THESE PLANS have been examined for compliance with the Ontario Building Code Requirements. A Building Permit is in Order to issue subject to any changes noted under the condition that the building will be constructed in accordance with the code

WILLOW 3E (GR)
ELEVATION 1, 2 & 3

TITLE SHEET
BARLASSINA CONSTRUCTION
CITY OF CAMBRIDGE

WILLOW 3E

BASEMENT PLAN EL-1
BARLASSINA CONSTRUCTION
CITY OF CAMBRIDGE

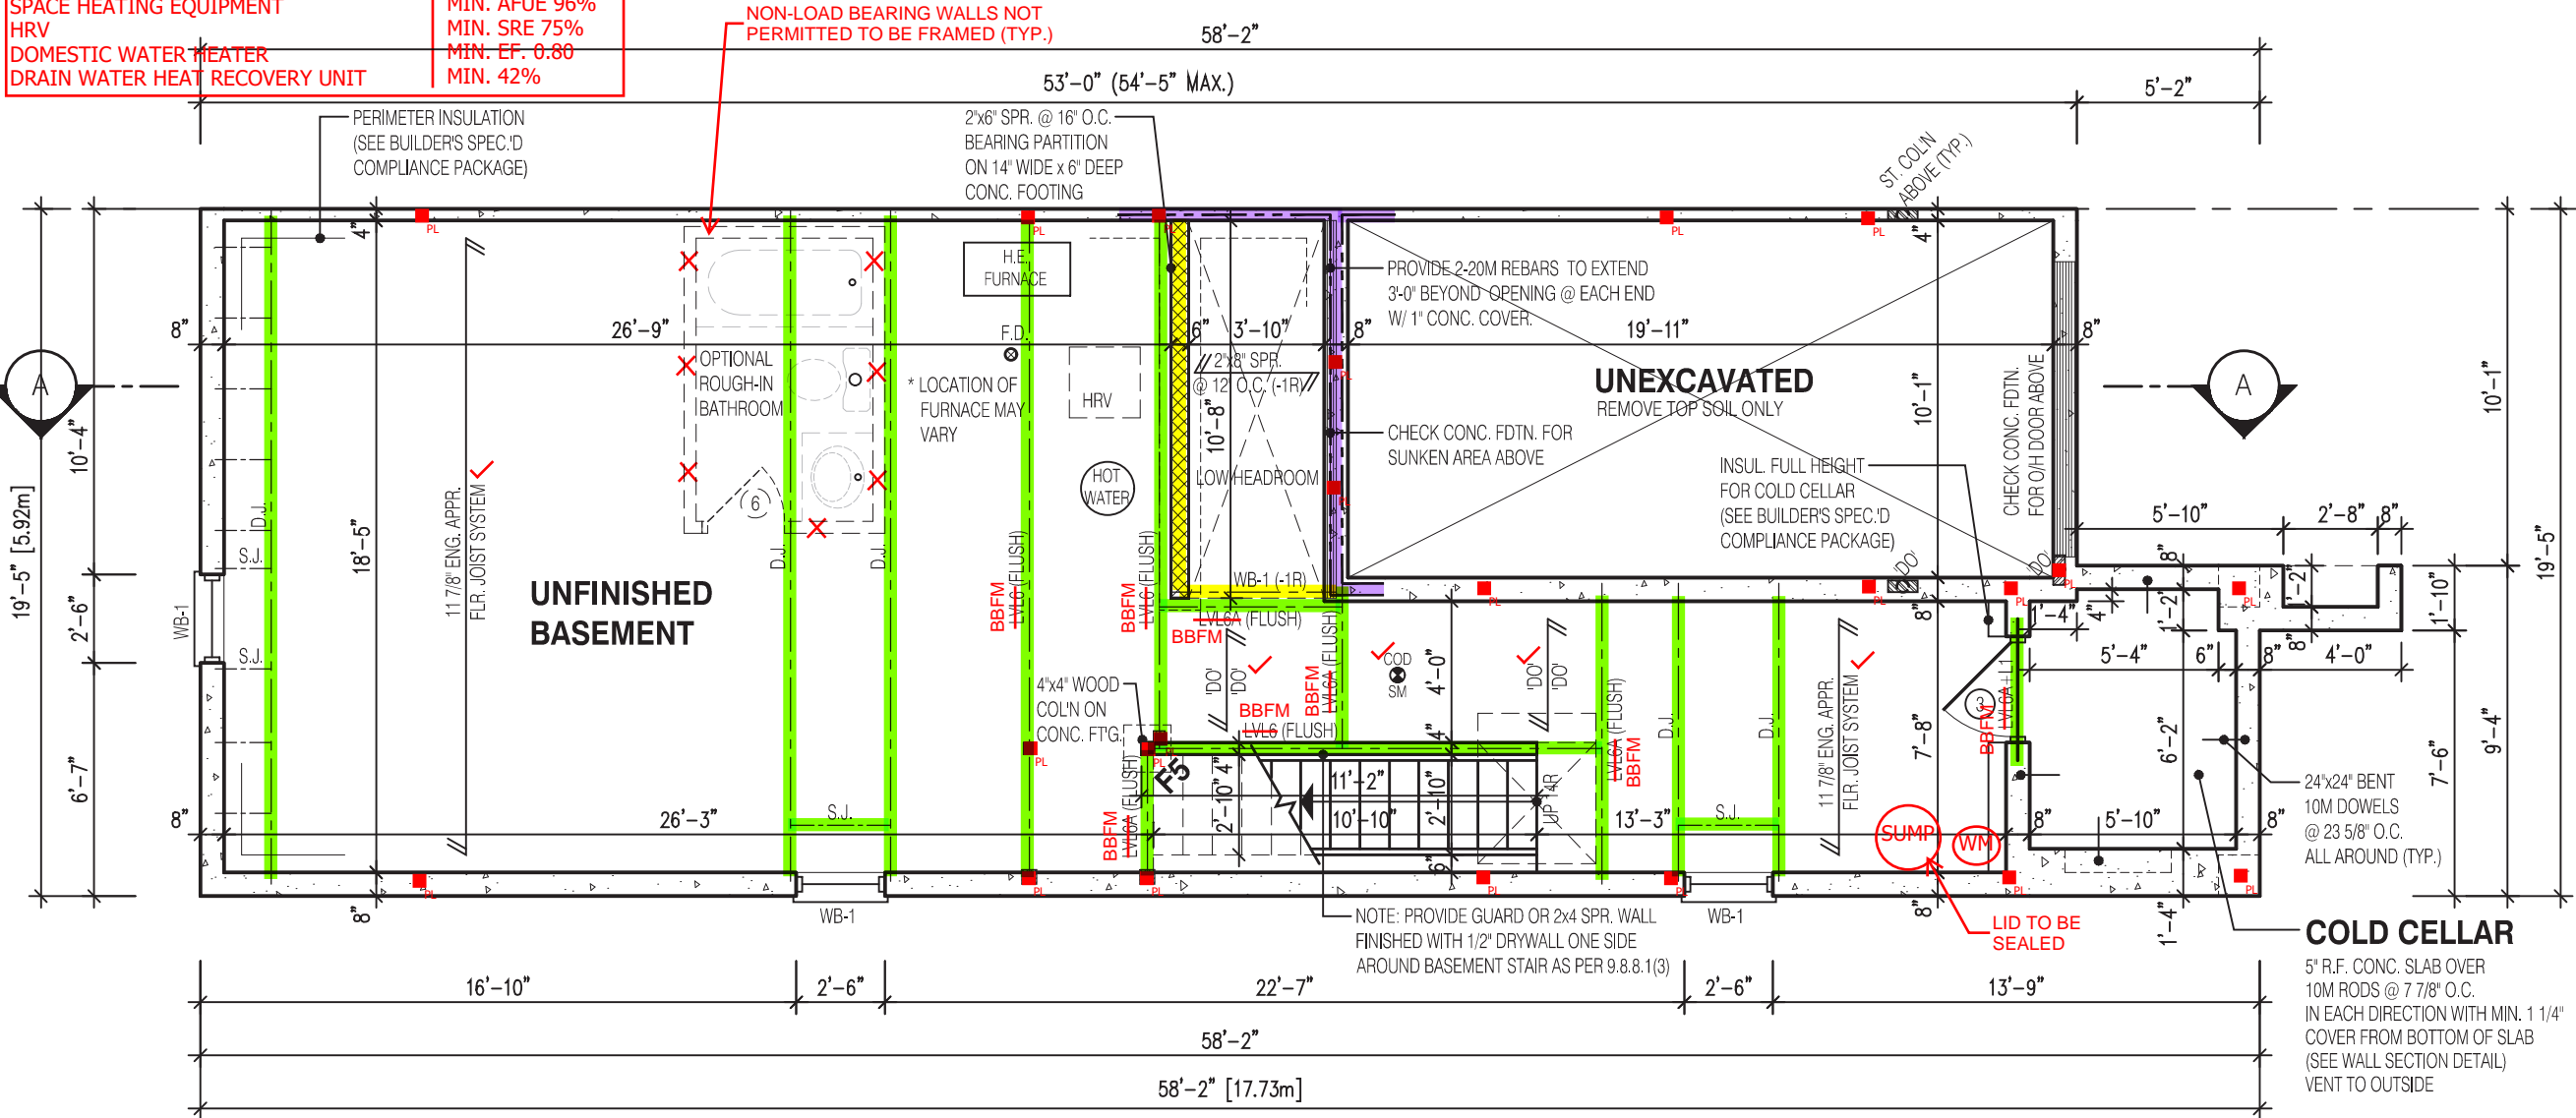
VERIFY WATER METER AND DWHR
UNIT LOCATION WITH INSPECTOR

SPRAY FOAM/RIGID INSULATION TO BE
PROTECTED AS PER 9.10.17.10.(1)

WATER METER TO BE INSTALLED WITHIN 2m
(6'-6") FROM THE POINT THE WATER SERVICE
PIPE MEETS THE BUILDING LINE

REQUIRED CONTINUOUS INSULATION
CANNOT BE INTERRUPTED BY FRAMING
MEMBERS SUCH AS STUDS

SIDE ELEVATION 1

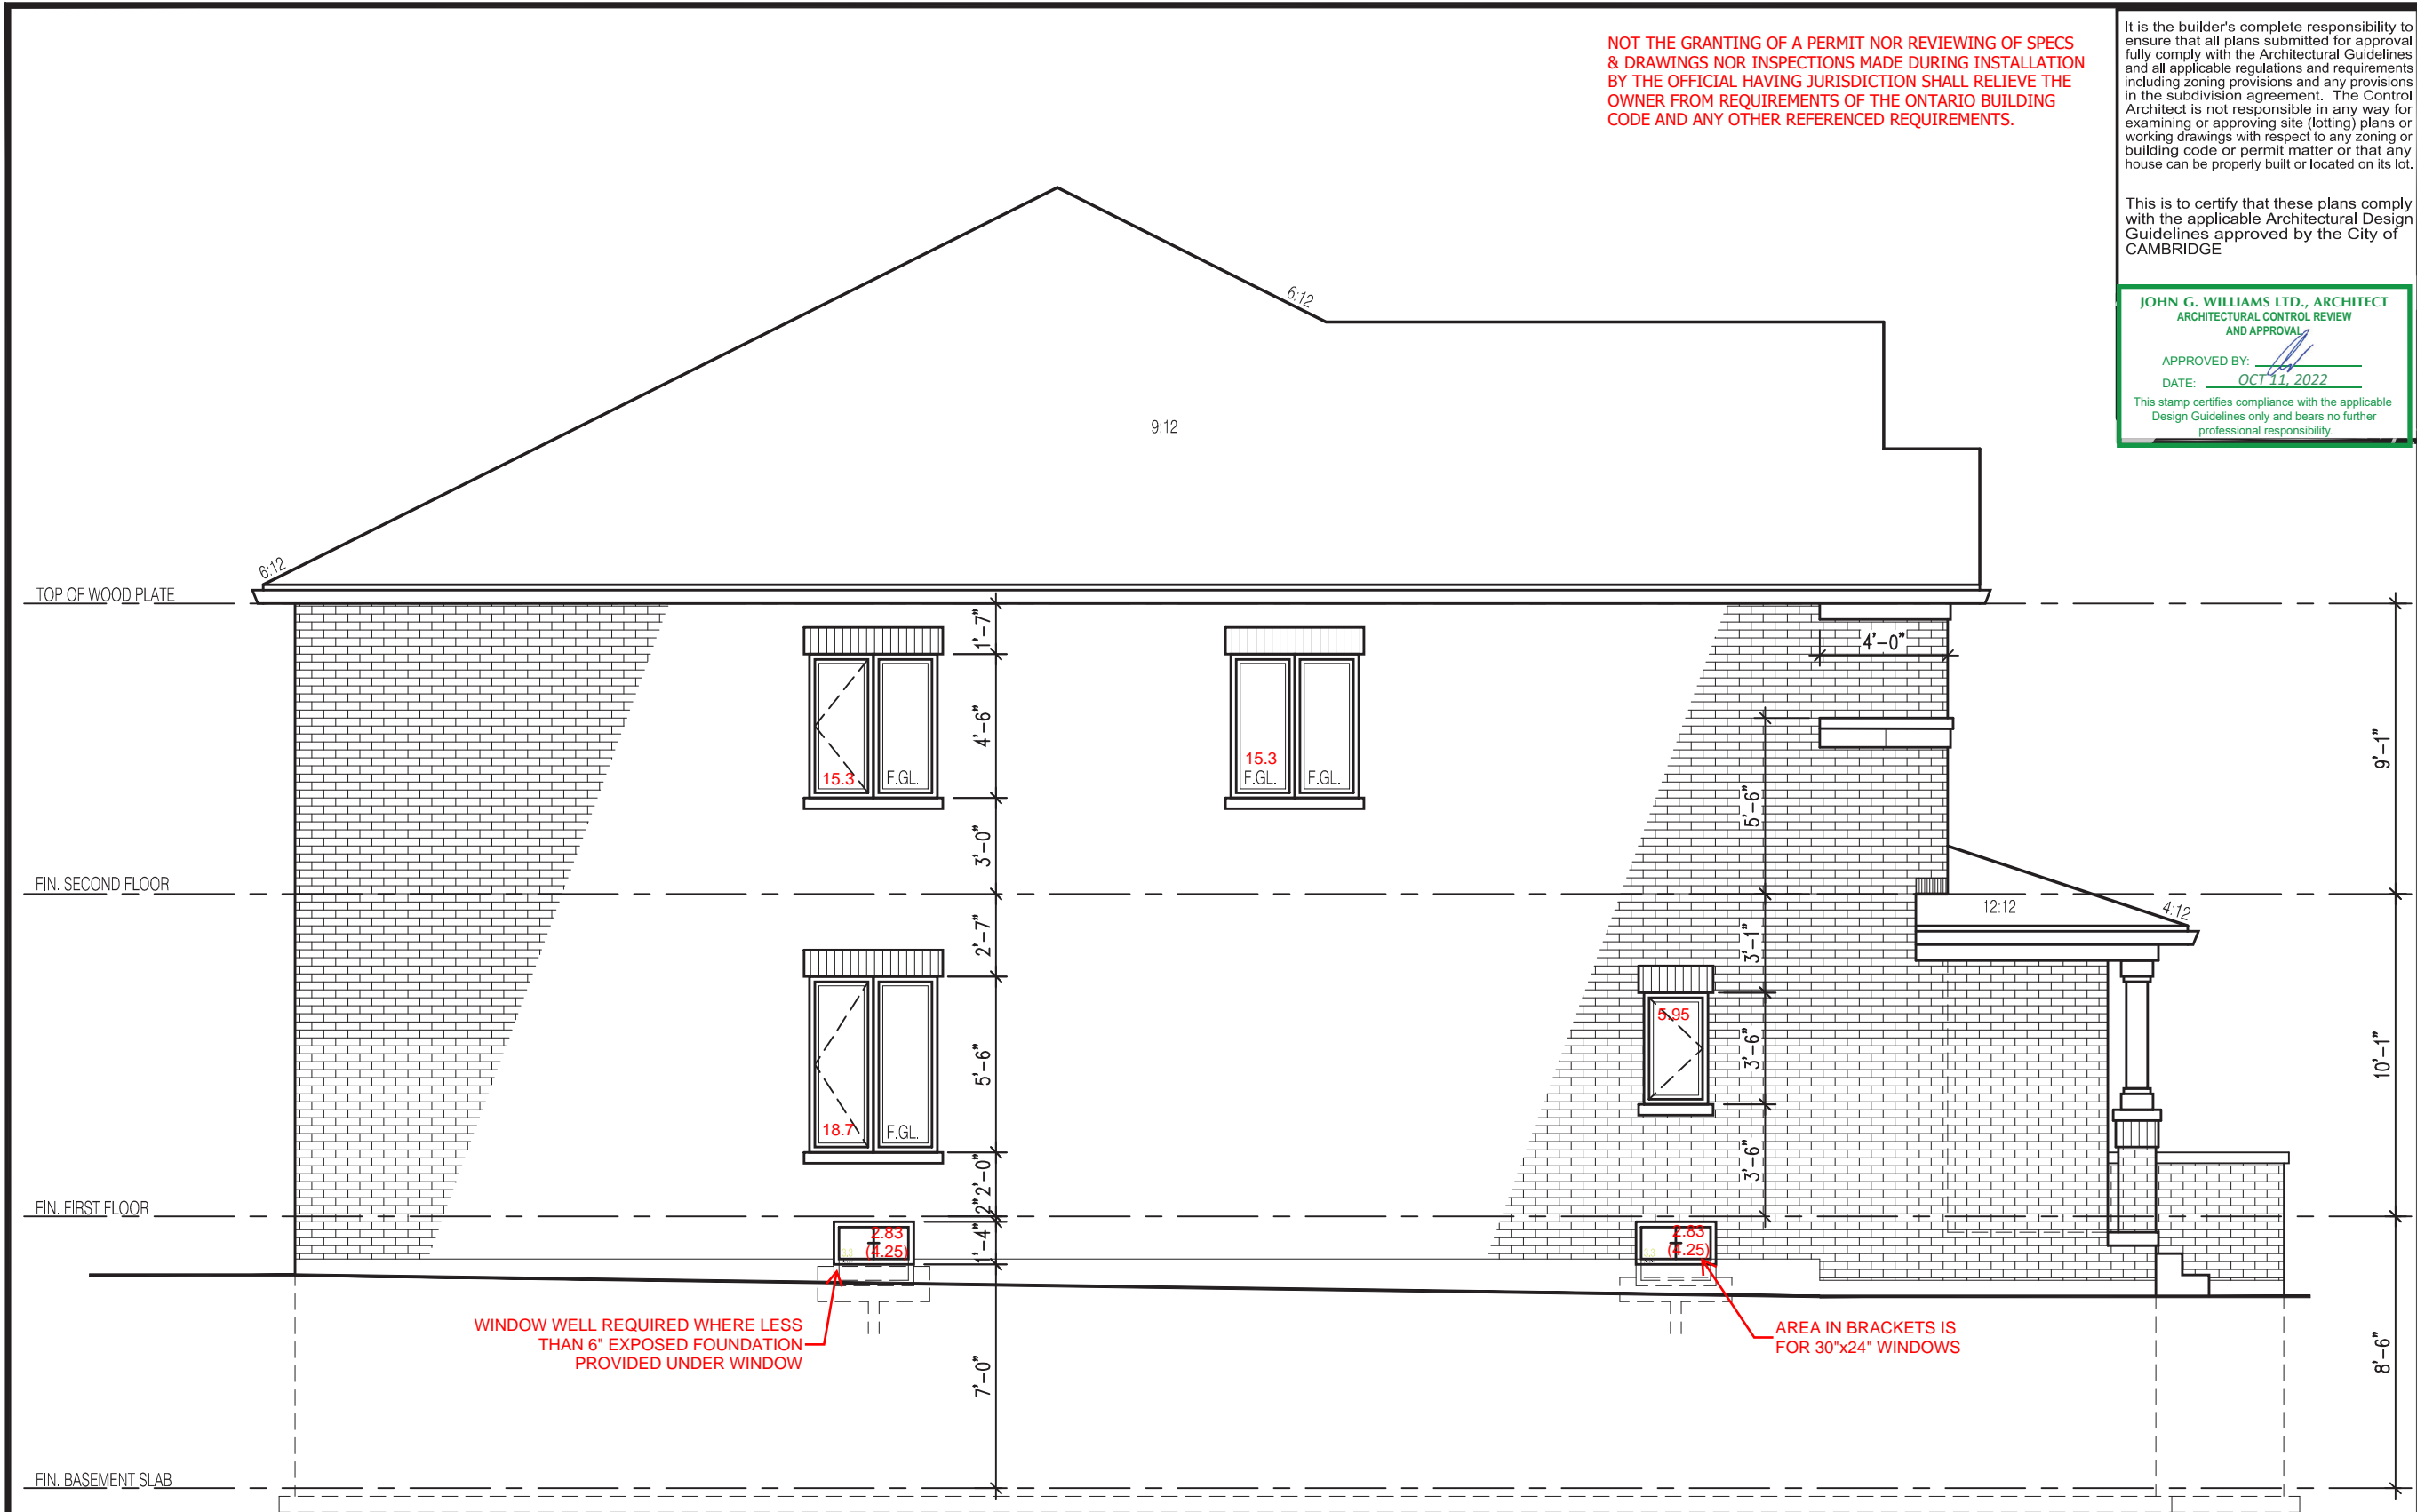
1161 ✓
81.27 ✓
~~71.60~~ ✓
60.91 ✓

1161 ✓
81.27 ✓
~~75.00~~ ✓
63.75 ✓
